**From:** [REDACTED] [REDACTED]@highwaysengland.co.uk>  
**Sent:** 16 March 2021 16:04  
**To:** [REDACTED]@planninginspectorate.gov.uk>; [REDACTED]  
[REDACTED]@planninginspectorate.gov.uk>; M54 to M6 Link Road  
<M54toM6linkroad@planninginspectorate.gov.uk>  
**Cc:** M54toM6linkroad <M54toM6linkroad@highwaysengland.co.uk>; [REDACTED]  
[REDACTED]@aecom.com>  
**Subject:** M54 to M6 Link Road - PROW Routes

**M54 to M6 Link Road**

**M54 JUNCTION 1 PROPOSED NMU SHORTCUT**

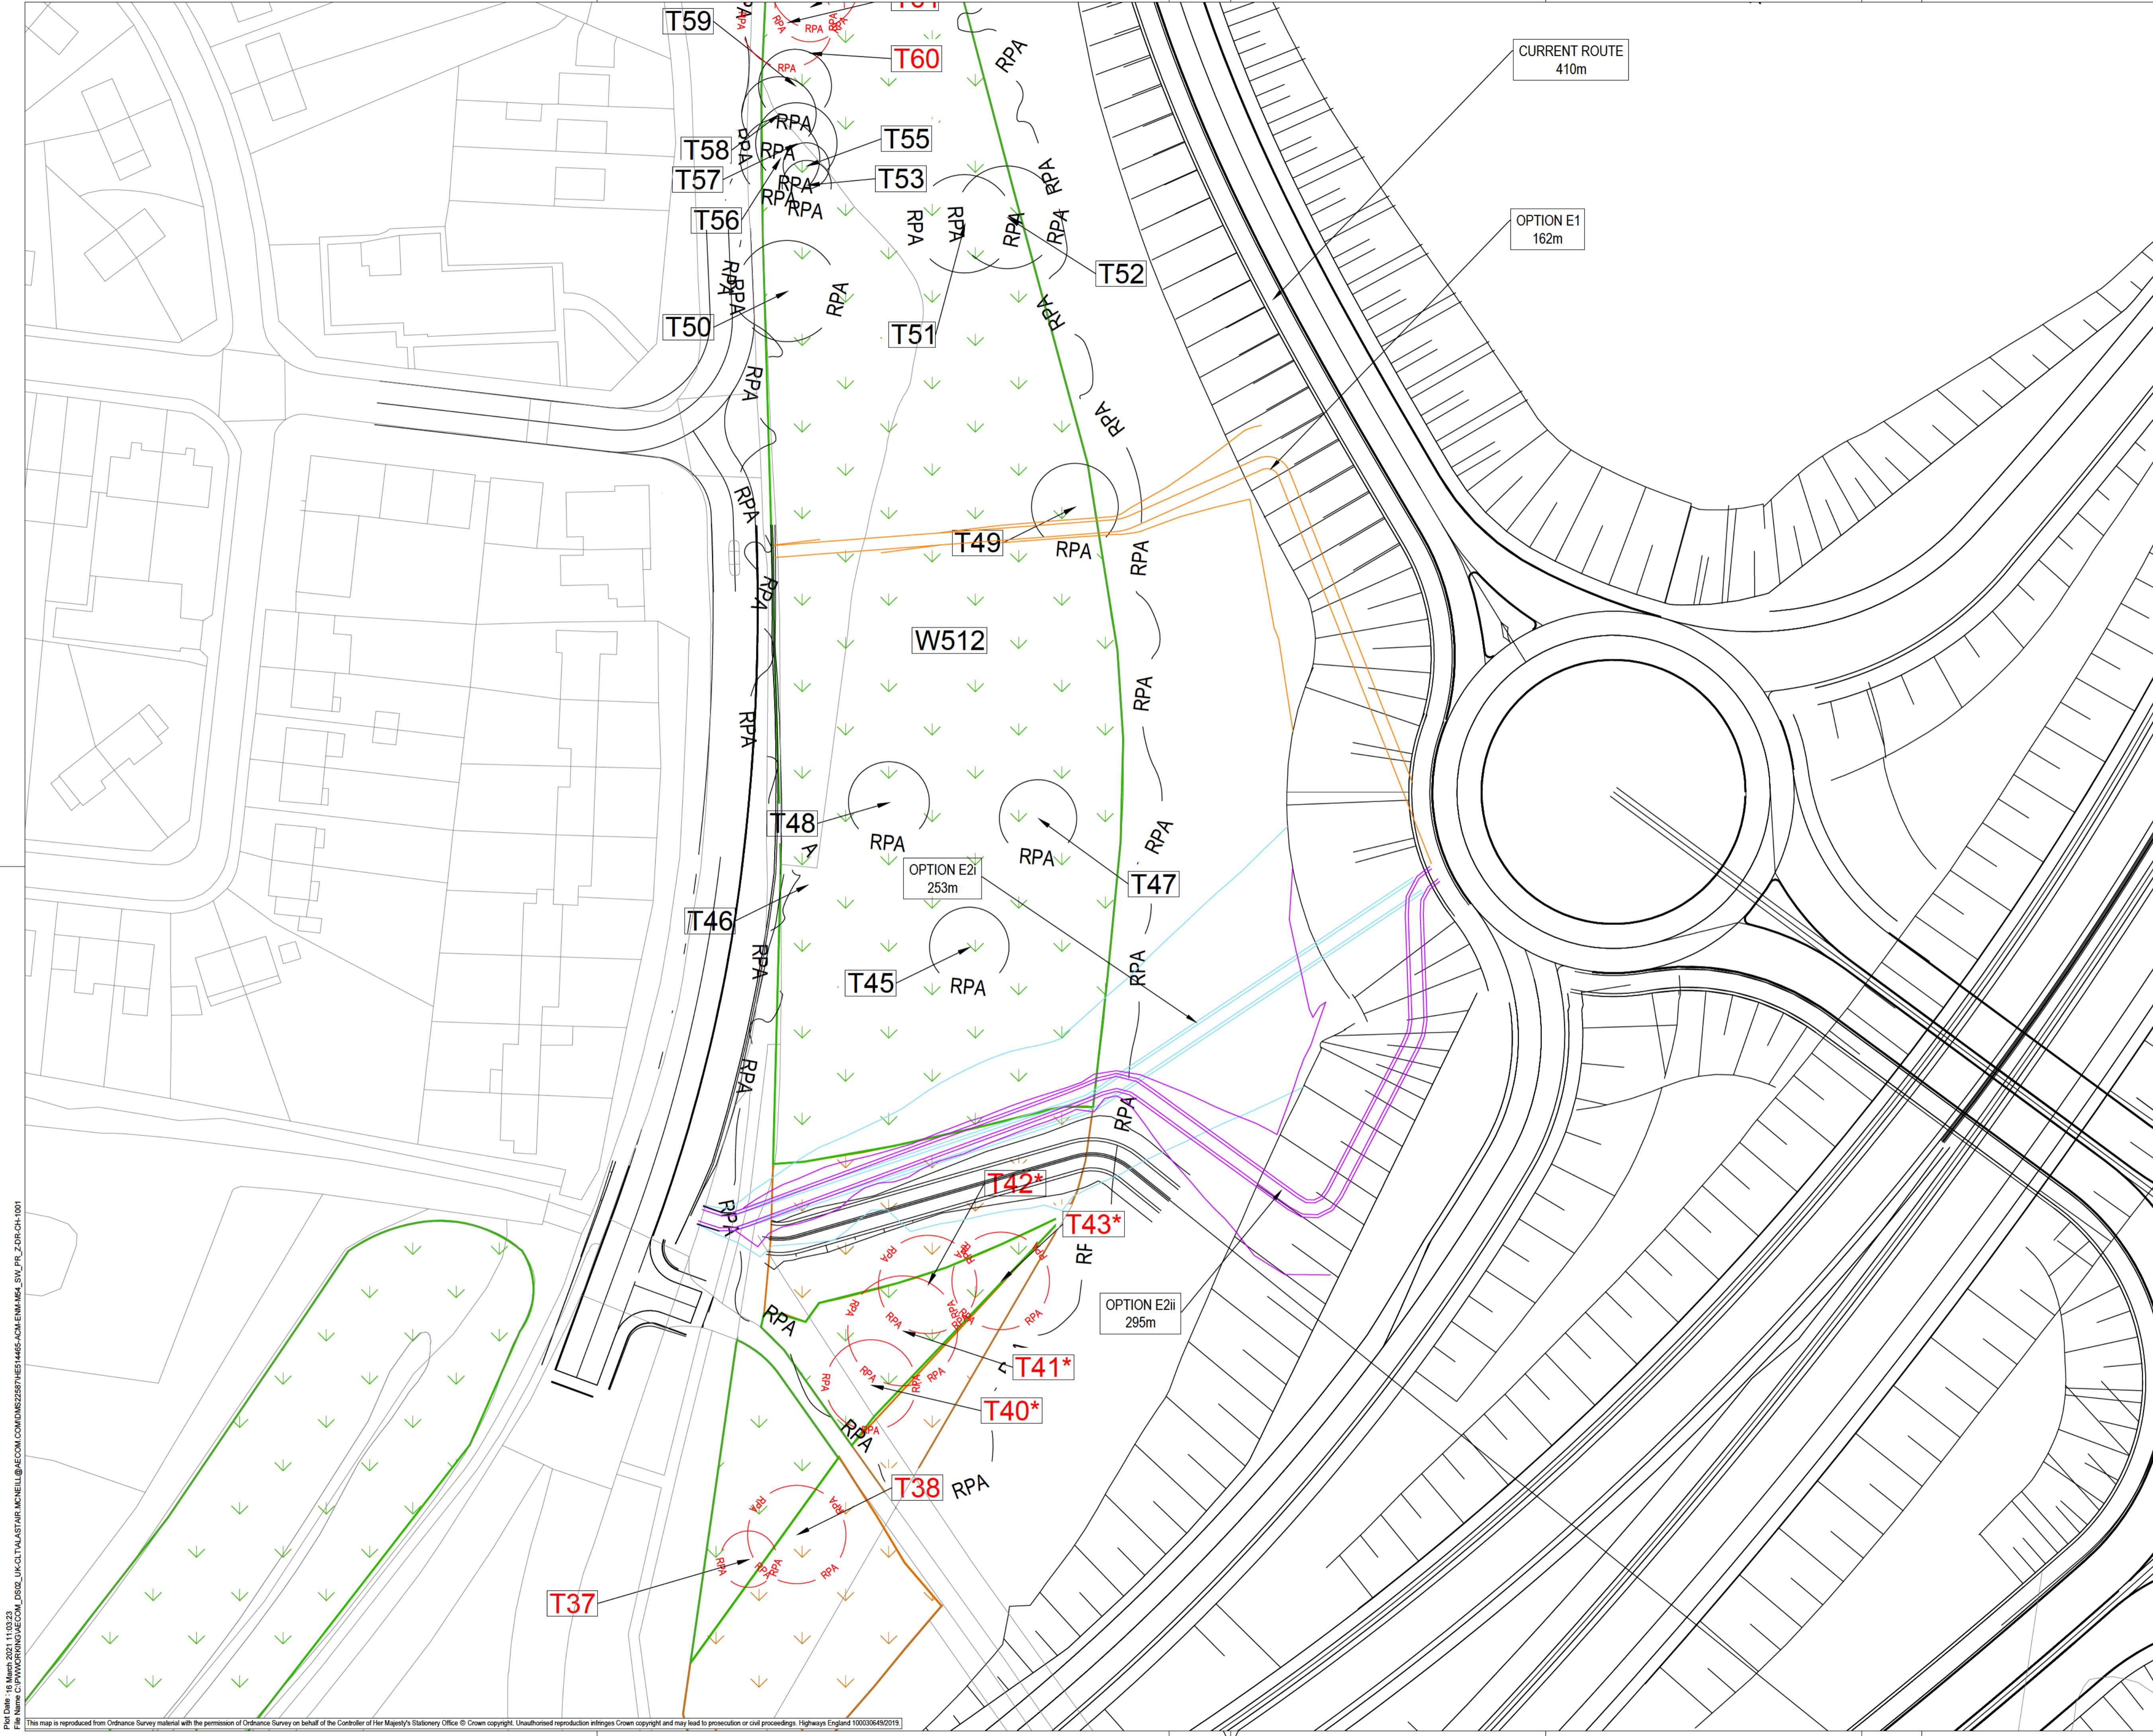
Detailed modelling of the route Option E2i (light blue alignment) indicates that in order to provide suitable gradients for all users then significant earthworks would be required resulting in a greater degree of woodland loss at this location. Due to levels raising above existing ground level through the woodland with this option by up to 2m, the earthworks vary from zero to up to 6m either side of the alignment at the eastern side of the woodland, resulting in additional woodland loss of approximately 1000m<sup>2</sup>. This would lead to ecological, landscape and visual impacts due to both the woodland loss and creation of the embankments. The route would need to be located north of the location shown on the attached plan to avoid the embankments affecting the watercourse. The route would have reduced the distance travelled by approximately 157m. Due to the increased environmental effects the team considered a slightly longer arrangement Option E2ii (purple) that minimised woodland loss, but the additional route length would erode the benefit the route provides, saving 110m in distance.

Following the above analysis, the team re-considered the Option E1 (orange) route in more detail and confirmed that it could be routed to avoid Root Protection Areas of trees where possible and be constructed to be sensitive to the woodland location. This route provides a greater benefit in terms of route length reduction and starts at a higher level along Cannock Road which reduces the level difference between Cannock Road and the roundabout. This not only reduces the amount of earthworks and tree loss required but also reduces the vertical level difference that users would need to travel between the two points. This route would reduce the distance travelled by approximately 248m. Our proposal is therefore to take forward a route that broadly follows Option E1, but amended to minimise tree loss. We would then add text to the OEMP to ensure construction techniques also minimises loss.

The proposed gradients and alignment for any of the options considered are not considered suitable for cycle users. The gradients and level landing areas (for wheelchairs and pushchairs) would encourage high speeds with a level of discomfort for cycle users. This could also increase the risk of collisions between cyclists and walkers. Due to the relatively short distance between the roundabout and Cannock Road, an alignment with suitable horizontal geometry and vertical gradient could not be provided within the engineering constraints without considerably increasing the distance required to travel. Furthermore, it is considered that cyclists would prefer to use the slacker gradient of the realigned A460 and would be less sensitive to the slight increase in distance travelled. Alternatively, they could use the proposed shortcut route if dismounted.

It is therefore proposed that Option E1 is implemented as part of the Scheme as a footpath.
